SUBJECT: Responds to 880518 & 0622 request for addl info re anticipated transients w/o scram.

Re: St. Lucie Plant Unit Nos. 1 and 2
Docket Nos. 50-335 and 50-389
Request for Additional Information
Anticipated Transients Without Scram

FLORIDA POWER & LIGHT COMPANY
ST LUCIE PLANT - UNITS 1 & 2
ATWS: RESPONSES TO NRC QUESTIONS
OF MAY 18 and JUNE 22, 1988

FIGURE 1

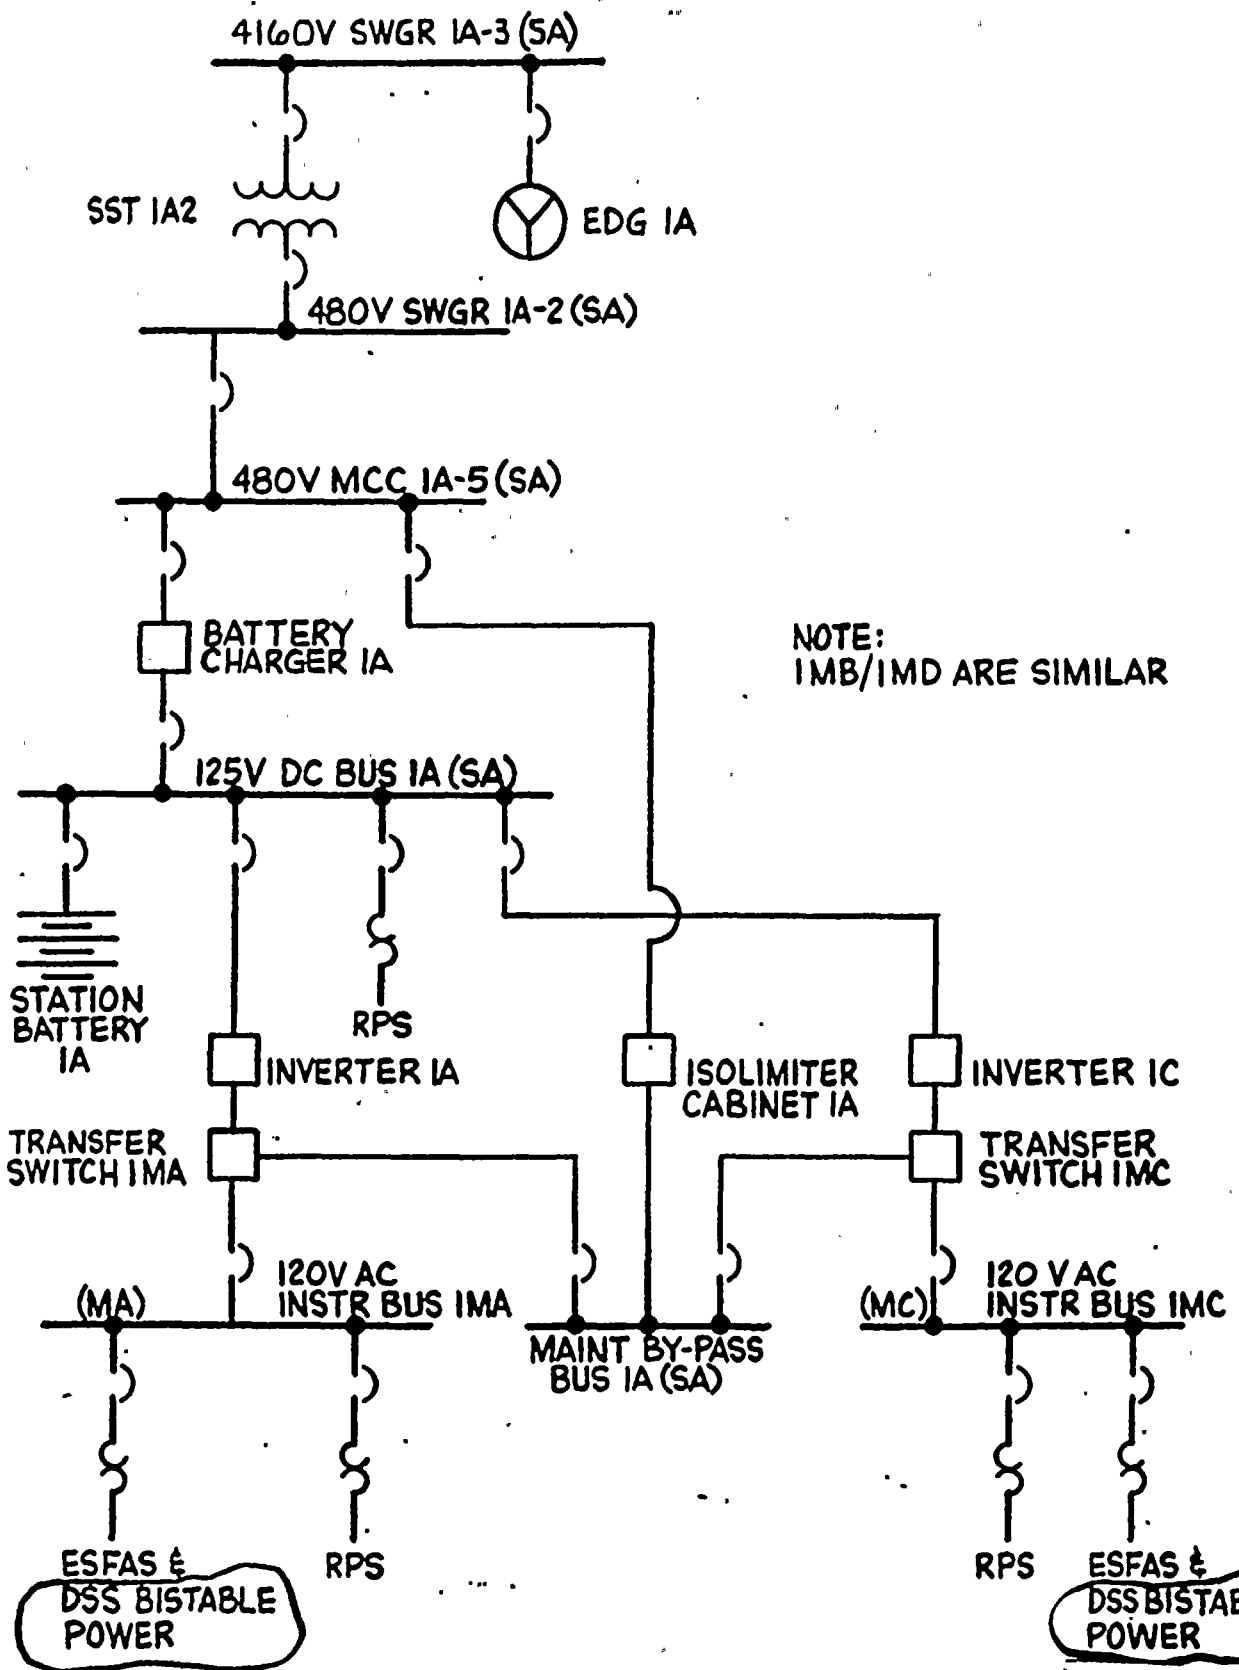
- a) Is the staff's understanding correct. If not, please explain.
- b) Part 1: Please provide electrical schematic/elementary diagrams for the DSS that clearly show all instrument channels (including bistables), logic, actuation circuits, test circuits, interlocks, bypasses, alarms and indications.

Part 2: Also, provide electrical one-line diagrams showing the CEA drive MG sets and DSS actuated output breakers, and power distribution to the RPS and ESFAS/DSS, including vital buses, inverters, batteries and chargers.

Figures 1, 2, 3, and 4 include electrical one-line diagrams for the RPS and ESFAS/DSS, including vital buses, inverters, batteries, and chargers. Figures 5 and 6 include electrical one-line diagrams for the CEA drive MG sets.

FIGURE 2

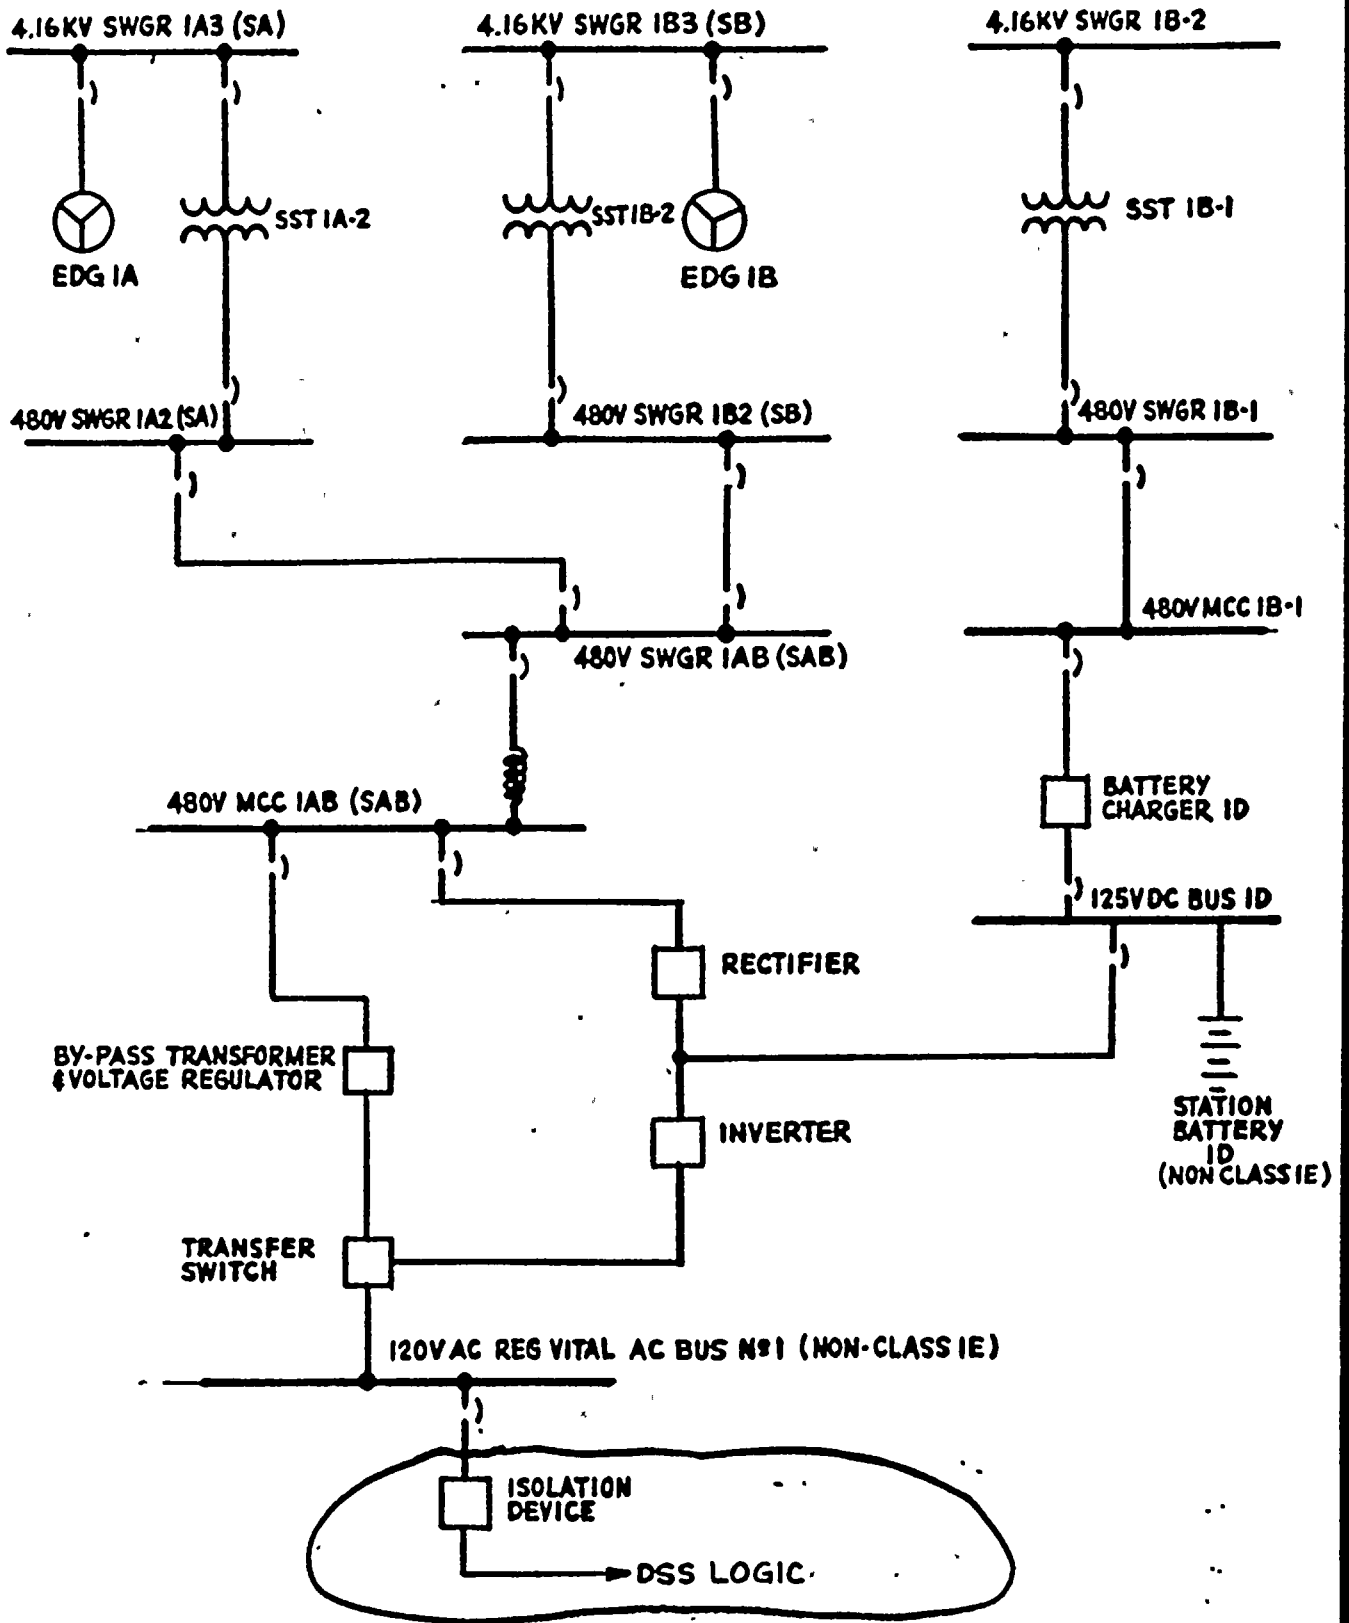
Electrical independence is required between the existing RPS and the ATWS prevention/mitigation systems required by the rule. The electrical schematic/elementary diagrams provided in response to Item 1 above should clearly identify all power sources used. Where RPS power supplies are used, it must be demonstrated that 1) faults within the DSS, diverse AFWS actuation circuits or diverse turbine trip (DTT) circuits cannot degrade the reliability/integrity of the existing RPS below an acceptable level, and 2) that common mode failure affecting the RPS power distribution system (including degraded voltage and/or frequency conditions, e.g., overvoltage and undervoltage; the effects of degraded voltage conditions over time must be considered if such conditions can go undetected) cannot compromise both the RPS and ATWS prevention/mitigation functions. If the St Lucie Units 1 & 2 design shares common power supplies for the RPS and equipment installed per ATWS rule requirements (i.e., DSS excluding sensors, and diverse AFWS actuation and DTT excluding sensors and actuation devices), provide the information for Items 1 and 2 above.

The one-line diagrams provided in response to question 1 identify the power sources for the RPS and DSS logic (Figures 1 through 4). As shown in the diagrams, power for the DSS logic in both units will be through isolation devices from vital, non-Class 1E 120Vac buses, which are different buses than the Class 1E buses feeding the RPS. The normal distribution path for DSS power will be through an uninterruptible power supply connected to both safety (SAB) and non-safety buses (Figures 2 and 4). If there is a failure at the 480 Vac or 4160 Vac levels, the non-Class 1E station battery (1D or 2D) will provide temporary power to the DSS logic while the Class 1E station batteries provide temporary power to the RPS and ESFAS loads. The emergency diesel generators will provide long-term backup power through the safety AB buses to the DSS logic.

FIGURE 7

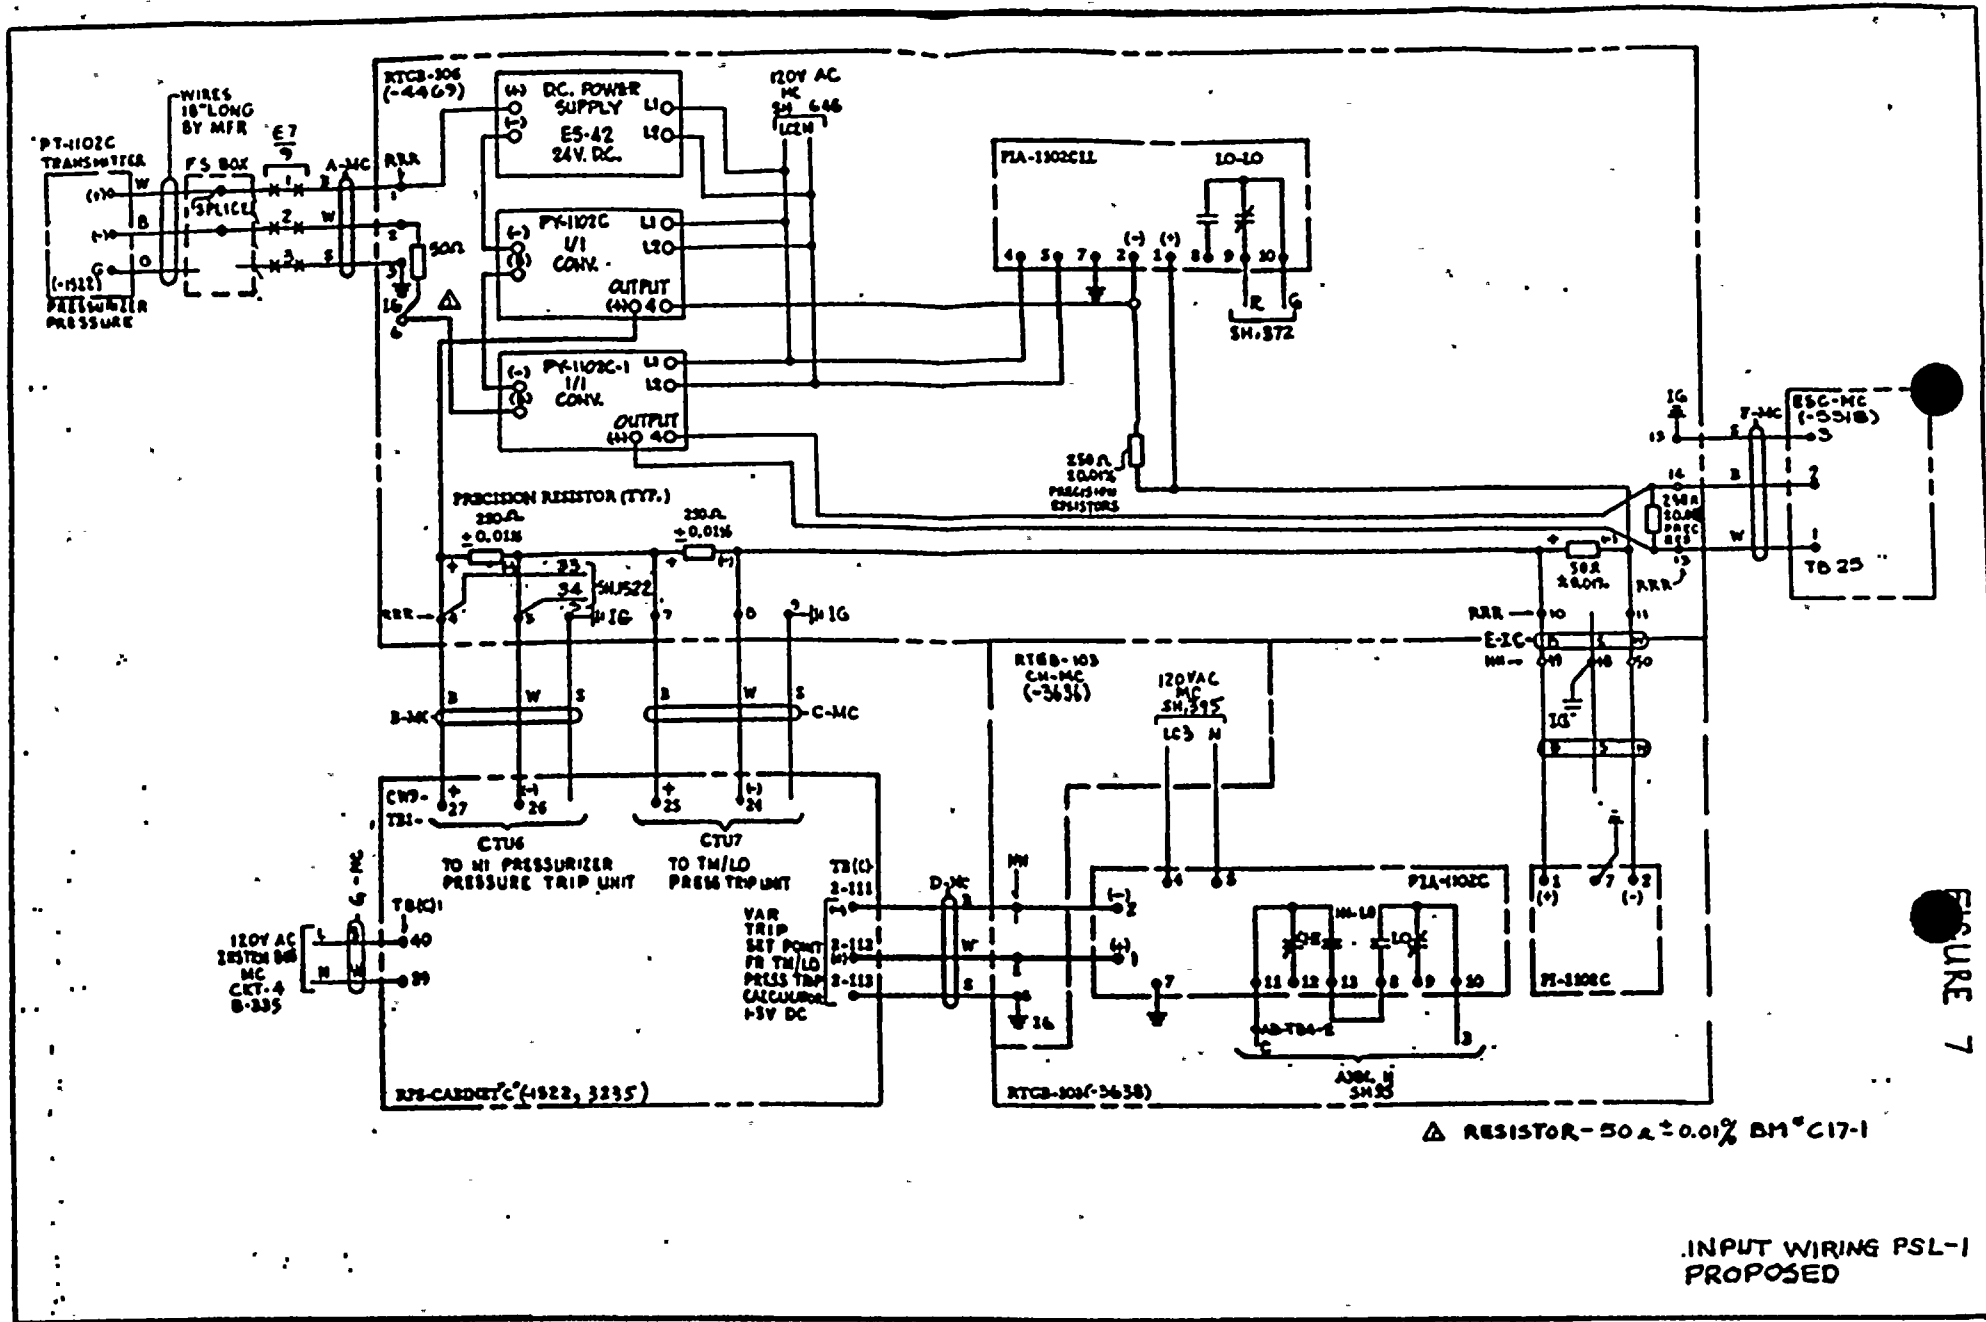
- a) Information must be provided to demonstrate the adequacy of all isolation devices used to protect the integrity of safety related circuits from non-safety related ATWS circuits. The required information is identified in Attachment 1*. If the isolation devices are identical to isolation devices used in other applications (e.g., to isolate the safety parameter display system from safety related circuits), and the requested information has been previously submitted for staff review, and the isolation devices have been approved for their applications, the related correspondence should be referenced, and no additional information need be provided.

Devices used to isolate the ESFAS/DSS circuitry from the safety related RPS are not yet installed in St Lucie - Unit 1. As can be seen in Figure 7, a single I/I (current to current) converter provides pressurizer pressure signals to the Sequence of Events cabinet, ESFAS cabinet MC, a pressure indicator in RTGB-103, and the RPS circuitry in RPS cabinet C. A second similar I/I converter will be installed in RTGB-106 which will supply pressurizer pressure signals to ESFAS and the DSS circuitry. This is similar for the other three pressure loops.

ST. LUCIE PLANT UNIT NO. 1
TURBINE TRIP - REACTOR TRIP
SWITCHGEAR UNDERVOLTAGE

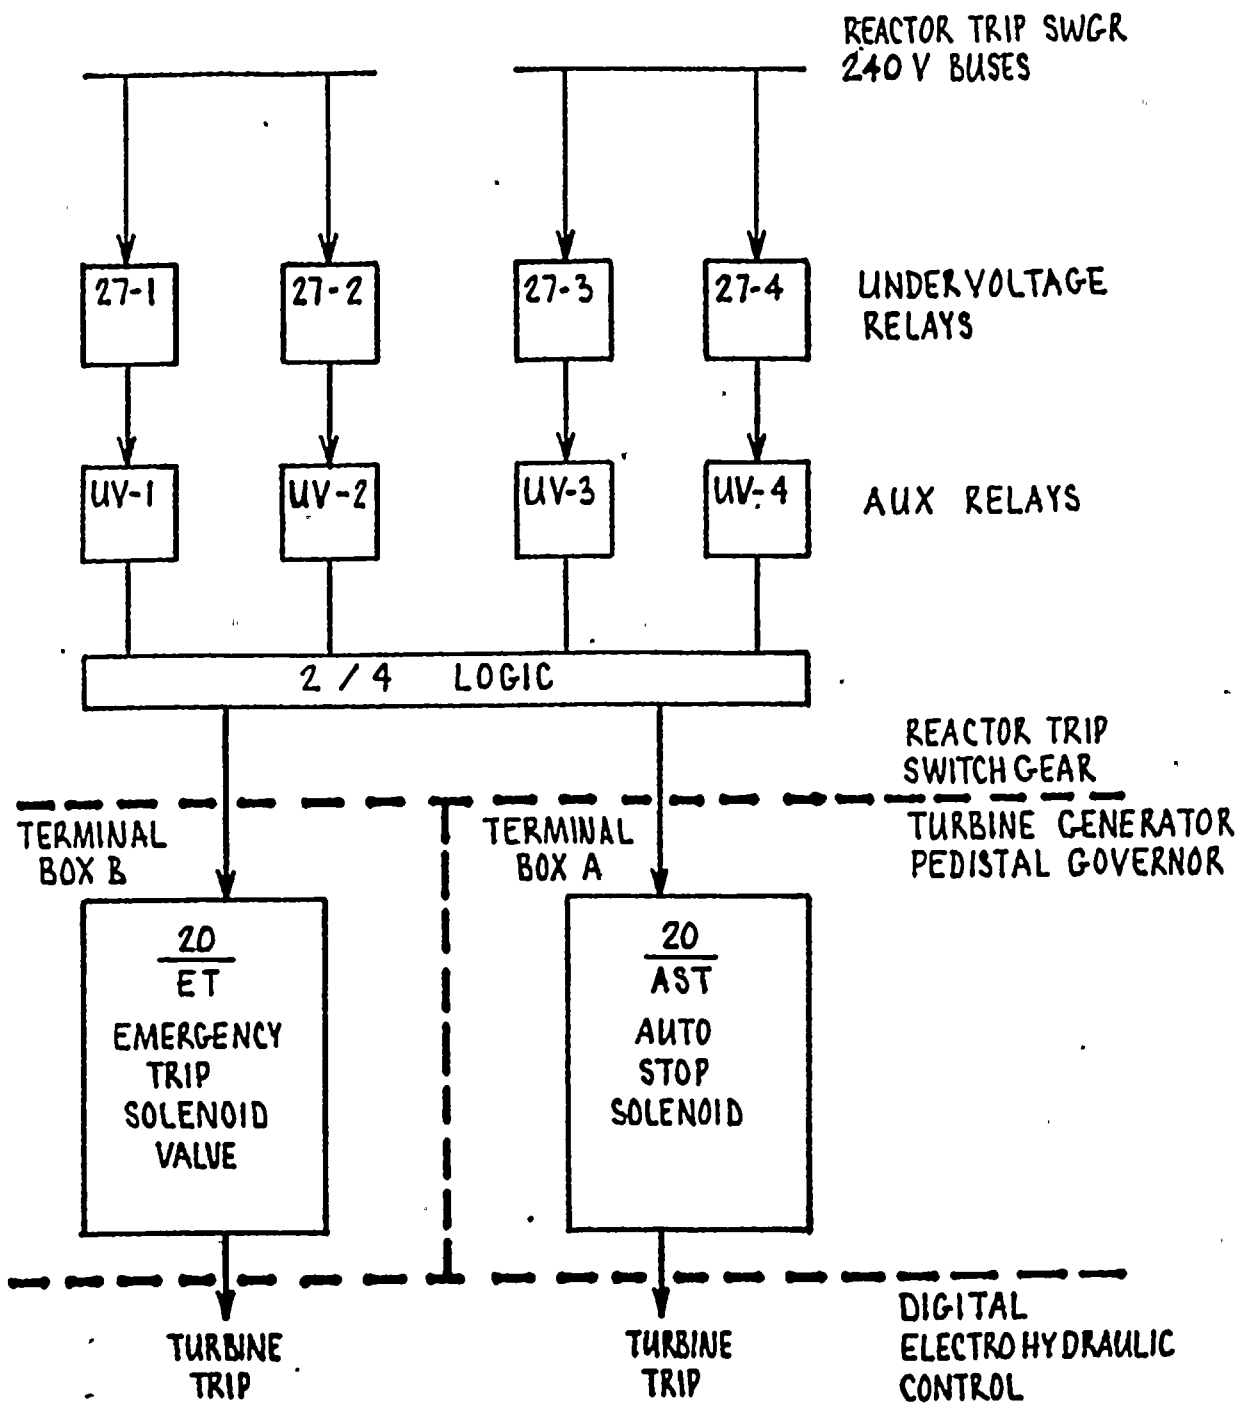
FPL's July 15, 1987 letter states that inherent to the DSS design is a turbine trip independent and diverse from the RPS, which is initiated by undervoltage conditions sensed in the CEA drive control system. Explain in detail how this arrangement satisfies the ATWS rule requirements for a diverse turbine trip. Please provide electrical schematic/elementary diagrams of the DTT circuits.

The existing turbine trip is diverse from the RPS in that the actuation of the turbine trip is based on an undervoltage condition in the reactor trip switchgear and is not based on the RPS logic. This assumes that there is an operational DSS which causes the undervoltage condition regardless of the status of the reactor trip breakers. As can be seen in the one-line diagrams in Figures 9 and 10, there are four voltage sensing devices (different devices for each Unit) that are fed into two 2/4 logic circuits, which in turn actuate to the auto trip solenoid and emergency trip solenoid valve to release auto stop hydraulic oil and emergency trip hydraulic oil, respectively. Loss of hydraulic oil pressure from either source will cause a turbine trip.
